From: Brian <brian46074@aol.com>
Sent: Monday, July 6, 2015 12:43 PM
To: APC; Council Members; Matt Skelton
Subject: 1507-ODP-17 & 1507-SPP-17 Spring Mill Station SE Corner PUD
Attachments: WWCP-Ch2page16.pdf

Figure 9: Regulating minimum driveway separation and sight distances will improve overall access control.

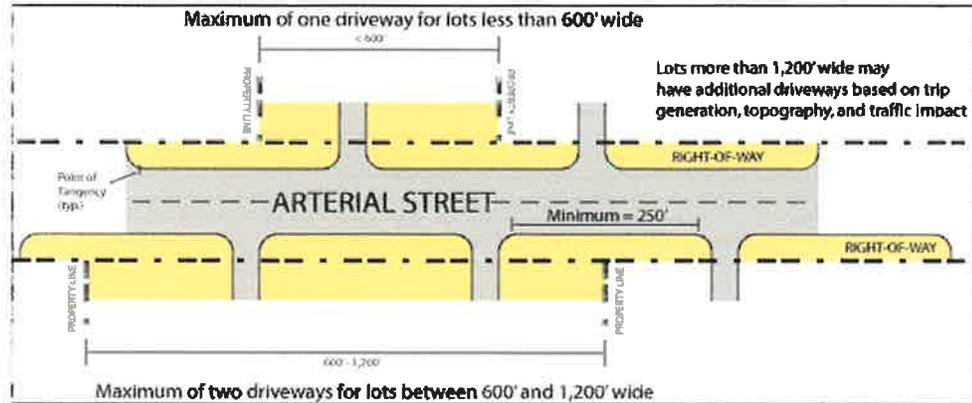
When checking the Westfield Washington Comprehensive Plan in Chapter 2, page 16, is a graphic about regulating minimum driveway separation in regards to arterial roadways. In the Comp Plan, it states: Maximum of one driveway for lots less than 600 feet wide. Also the minimum is 250 feet between drives. Page 16 is attached to this email. It appears the plan for this project does not adhere to the Westfield Washington Comprehensive Plan.

Is it possible to delete the right-in, right-out drives? These right-in, right-out drives interior of the development will cause additional traffic conflict points. One has to look just across the street to the north to see multiple conflict points between the Chase Bank and Pizza Hut. I ask that you request the petitioner to reconsider the use of the RIRO drives so close to the Spring Mill/161st intersection. I believe their plan will work (and better) without them. Thank you.
